Our ref.: 23453-TW1

RE:- Cranwood House, 100 Woodside Avenue, Haringey, London N10 3JA.

TWUL Comments on 27/06/2023

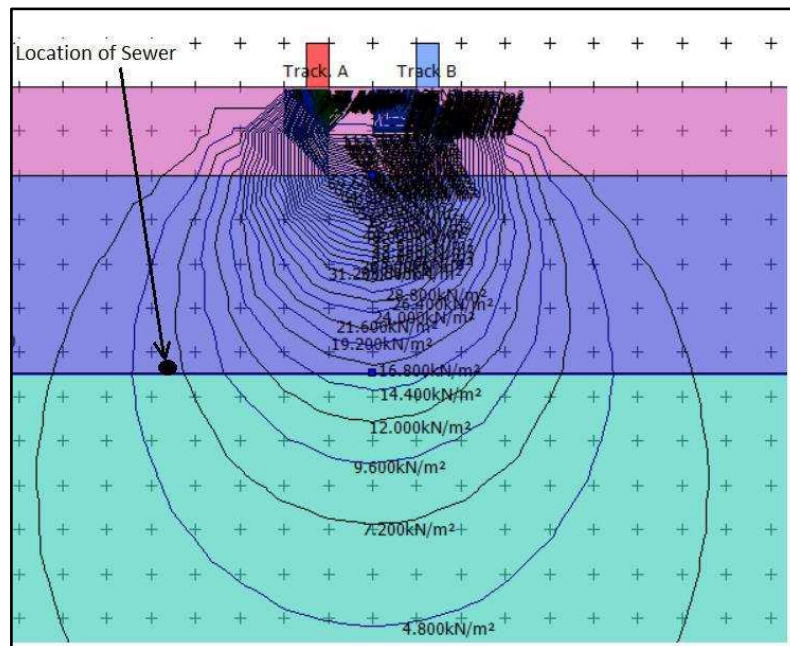
9. Page 11 – It is important to note that a gradient (slope) assessment approach is fundamentally flawed when assessing continuous linear structures (e.g. pipes). It is because it is the axial and flexural strain (curvature) which causes damage to the utilities. Gradient (slope) does not have any relations to these parameters.

It is important to note that flexural displacement (i.e. resultant of vertical and lateral displacements) is used to calculate curvature and associated changes in strain and joint rotation. Your calculated joint rotation only considers $\frac{1}{2}$ of the total joint rotation. Also, the change in strain has to be considered.

Doubling the rotation would bring the rotation to 0.1° . We have assessed the transverses strain as per the formula of Choy and New provided below. This indicates that the transverse strain is within the limits set by Thames Water.

0.3	5.4	19	6
Increased Moment on Pipe run (M)	= $[w(1-K_0)r/8]$	$W = 2\sigma_v r$	
	= $\sigma_v r^2(1-K_0)/4$		
M/I	= $2Ee/t$	$E = \sigma_v/\epsilon$	$I = t^3/12$
E = Youngs Modulus GPa	= 7	t = pipe thickness	Ko
		= 0.02	0.6
		Pipe Radius	
		= 0.150	
Transverse Crushing strain	= $[\sigma_v r^2(1-K_0)/4]/8IE$		
	= $3\sigma_v r^2(1-K_0)/2Et^2$

28.93	
Limits on Increase in Axial strain			
	Pipe Diameter	Tension	Compression
Vitrified Clay	<125	80	400
	>125	80	400
Concrete (unreinforced)	<225	20	400
	225 – 750	40	400
	>750	60	400
